Date: September 23, 2020
Applicability: XEM
Issued By: Jack Rader

BACKGROUND INFORMATION

Below is a cross section and external view of the modified gap joint vs the standard gap joint.

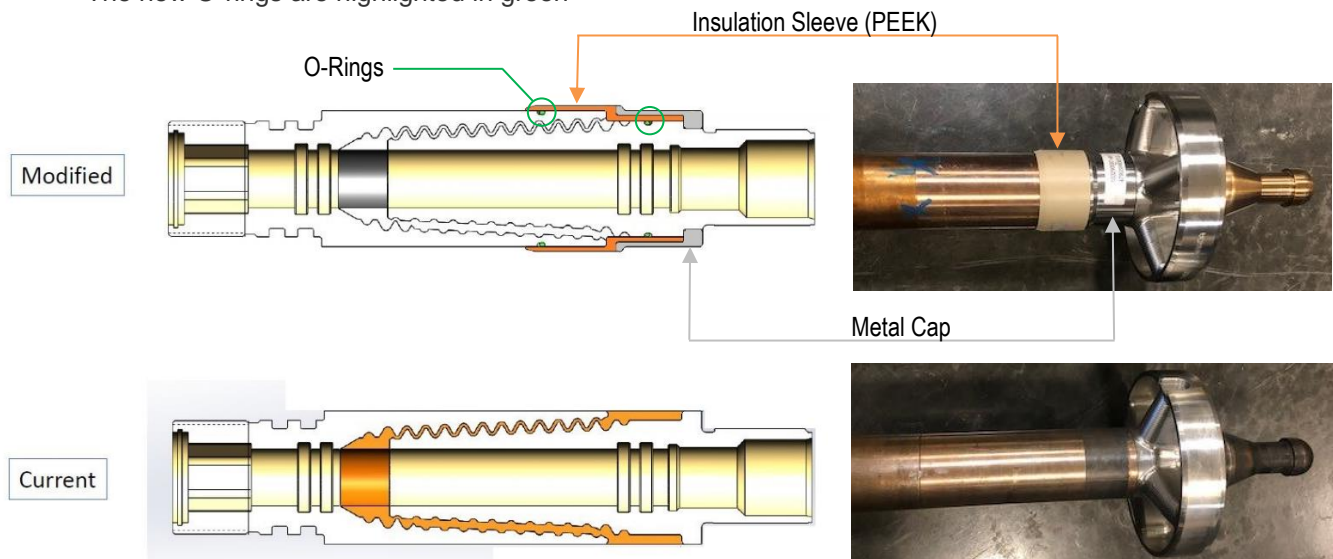
The modified gap joint is no longer directly exposed to the downhole environment. It is protected by two O-Rings under the new peek sleeve on each side of where the gap is exposed. This type of installation has already been proven on a larger scale with the xBolt Gap Probe.

- The new external insulation sleeve (PEEK) is highlighted in orange.
- The new external metal cap is highlighted in silver
- The new O-rings are highlighted in green

The modification can be done to any current gap joint that is in good condition. The gap joint is milled to accept the new insulations sleeve, O-rings, and metal cap before installation.

The new insulation sleeve creates a slightly larger diameter (1.875") than the barrel (1.75"). Additional precautions should be taken to avoid damaging the new PEEK that now protrudes from the tool below the landing spider.
